**Subject: Sub Catchment Drainage Plan for Fairways at Delacour**

**Response to comments**

**Response to comments**

# Sub Catchment Drainage Plan for Fairways at Delacour

FIGURE: 3

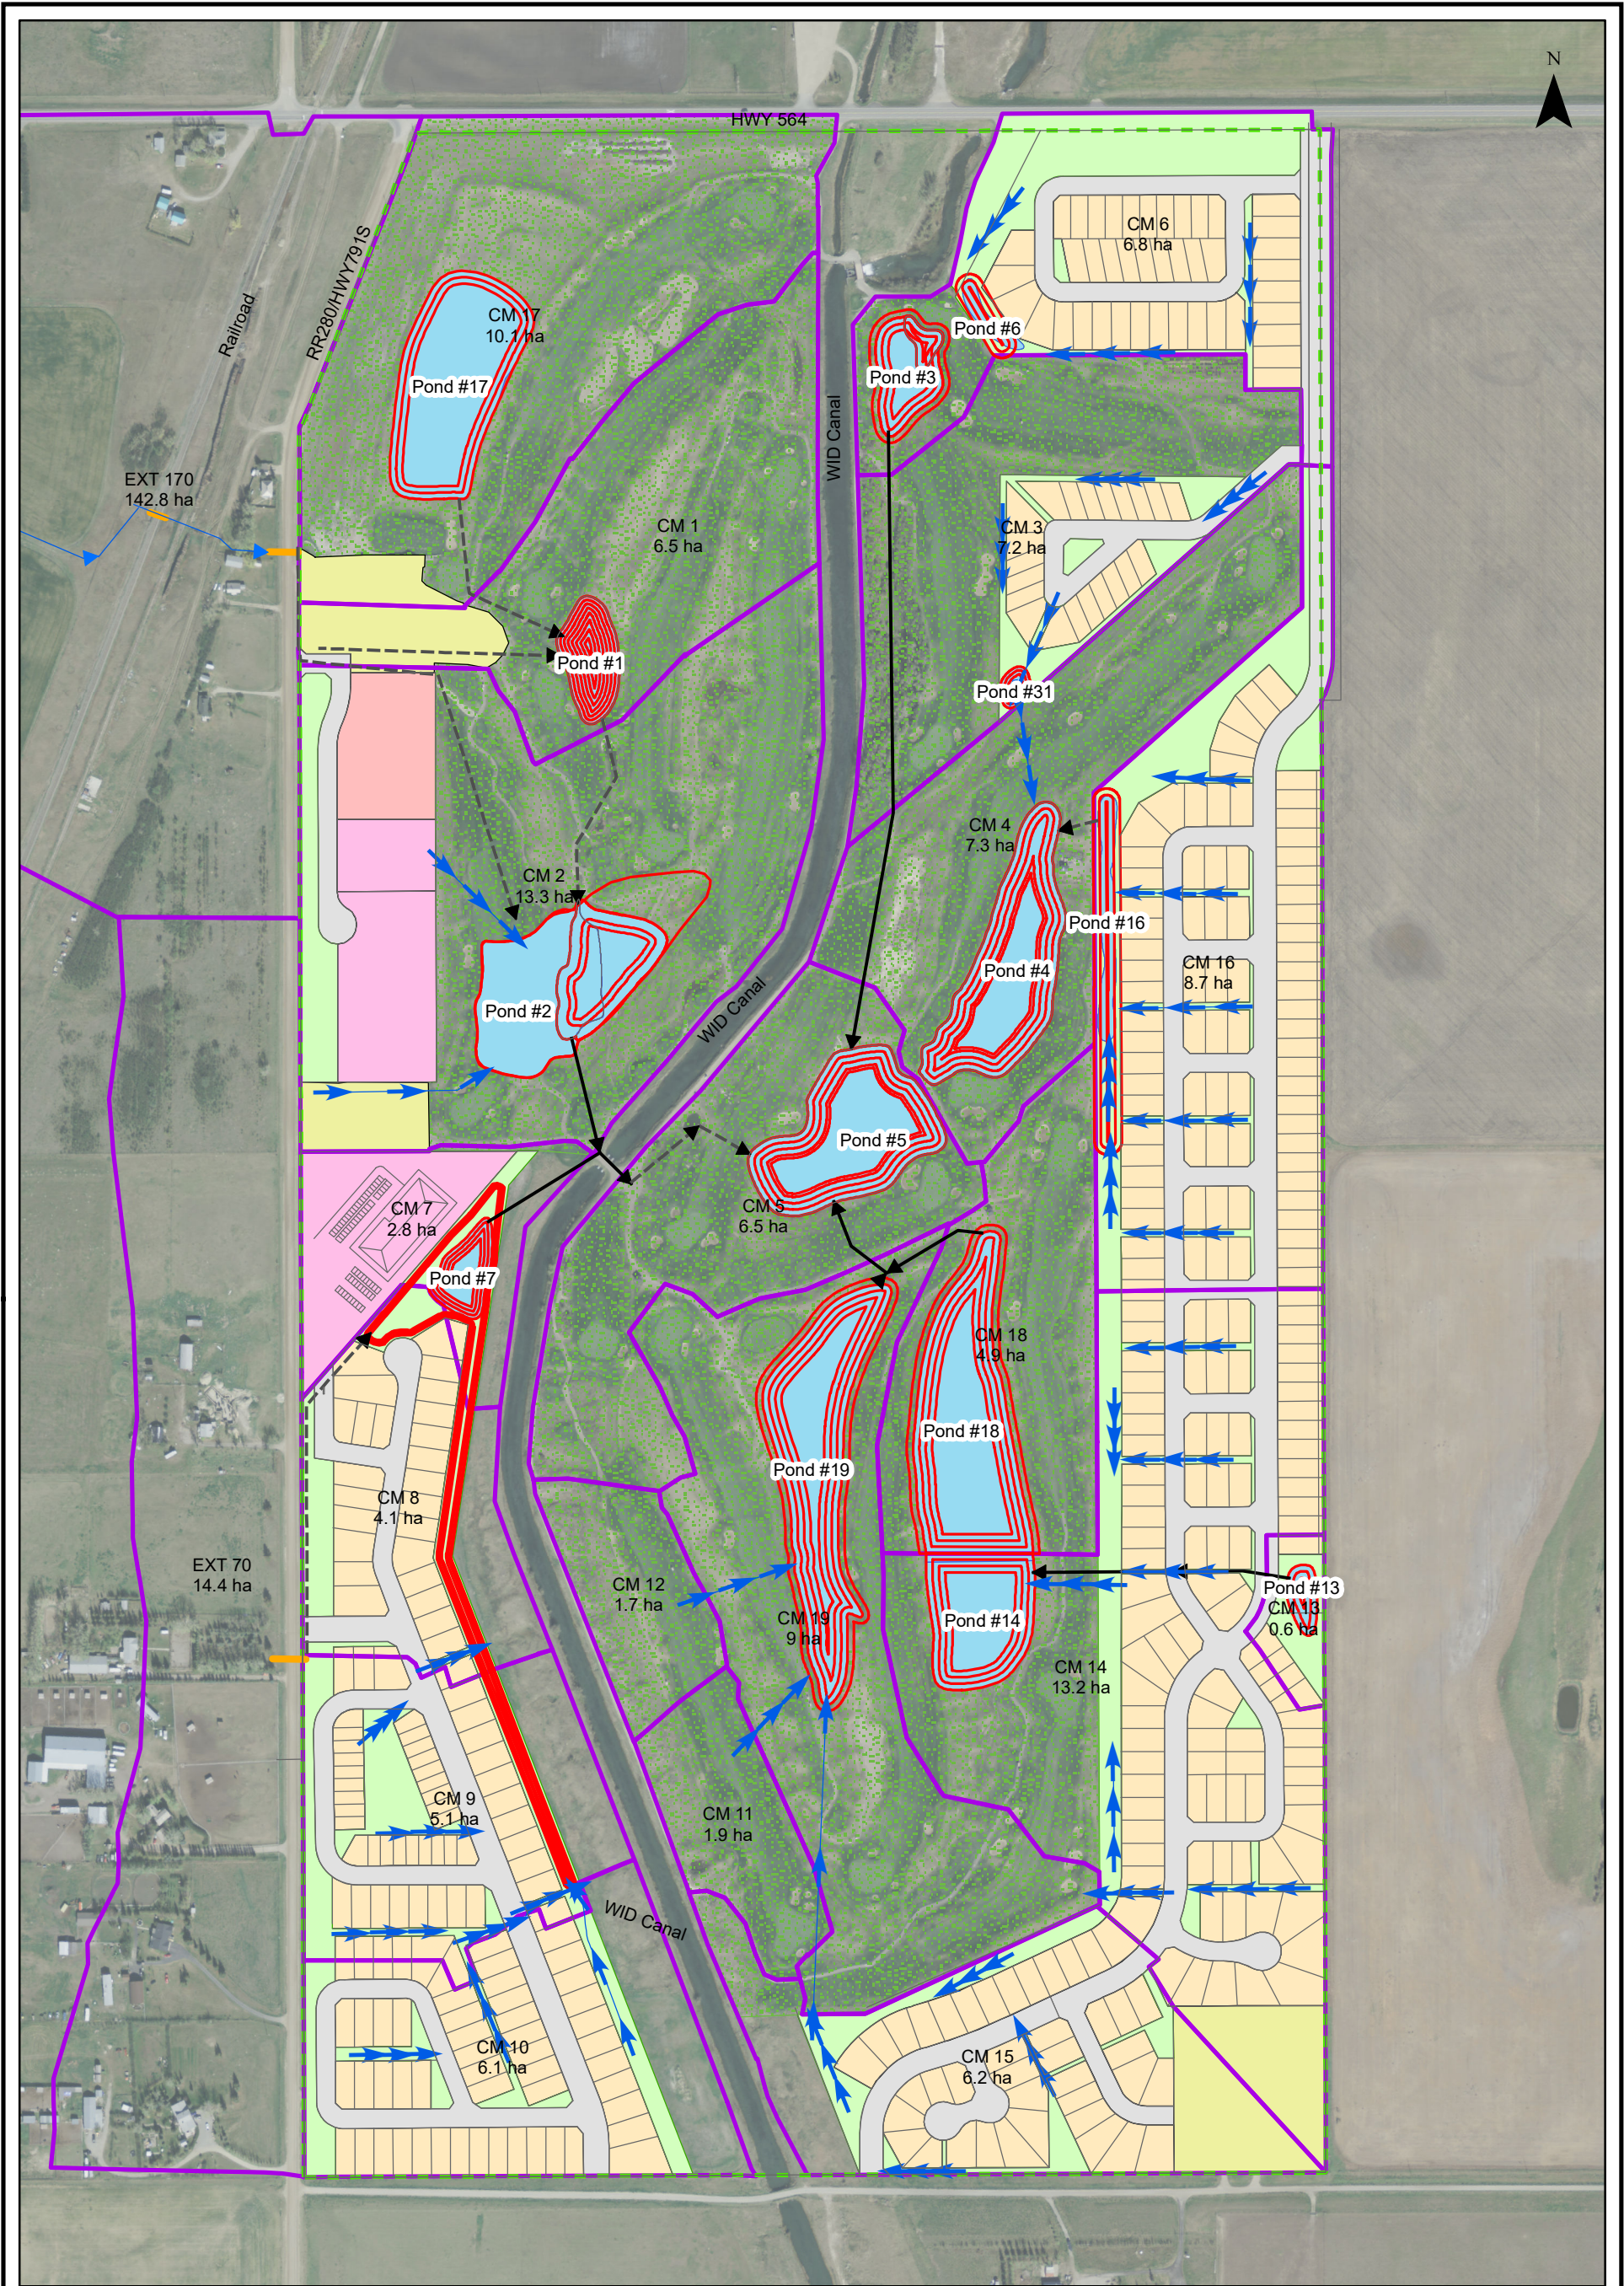
10. Comment: Add label for Pond 6 to Figure 3

*Response: Figure 3 in the updated SCDP has been updated accordingly.*
